# Product Change Notification

**Change Notification #:** 118767-00  
**Change Title:** Intel® Server Chassis R1304WFXXX  
PCN 118767-00, Product Design,  
Updating Tool-less carrier, adding a gasket on  
the riser bracket and including ODD support  
**Date of Publication:** December 13, 2021

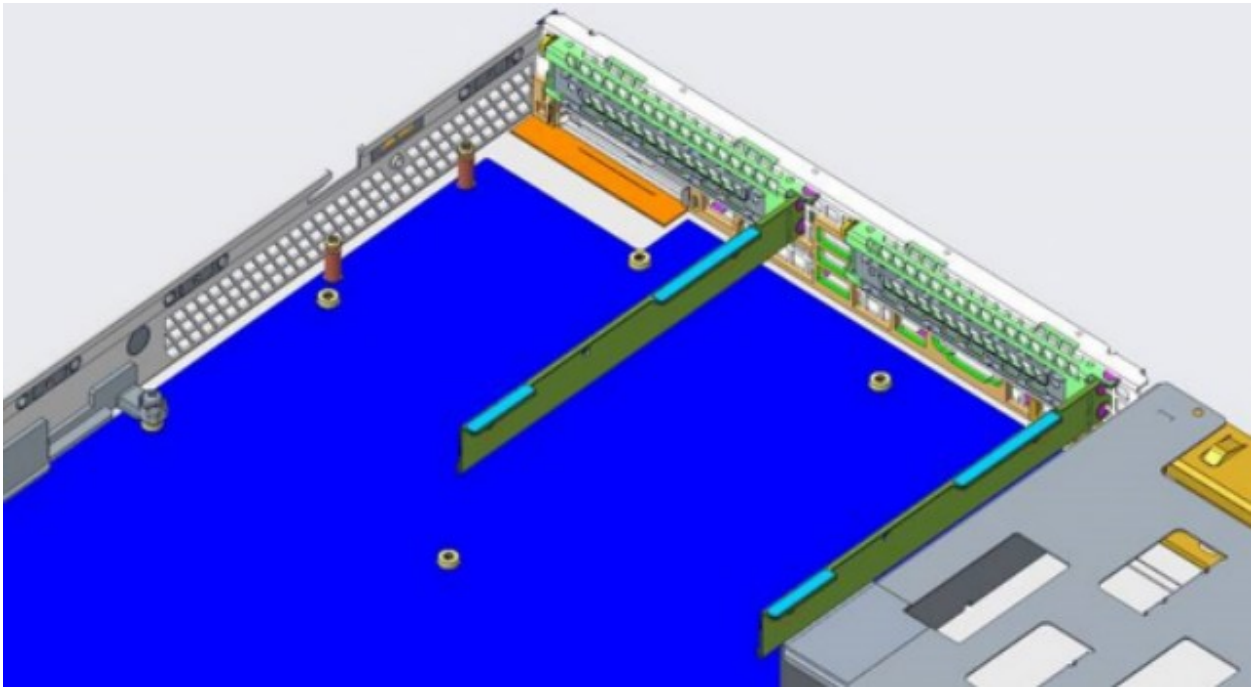
- For the 3.5" tool-less drive carrier when used for 2.5" drive support, from a non-removable to a new removable rear spring (see image in green) and new spring holder (see image in red) attached to the tool-less drive carrier.

- Removing the new rear spring of 3.5" tool-less carrier when installing 2.5" SSD drive, installing the rear spring to support 3.5" HDD.
- Adding a gasket on the riser bracket to improve the flow of electricity.
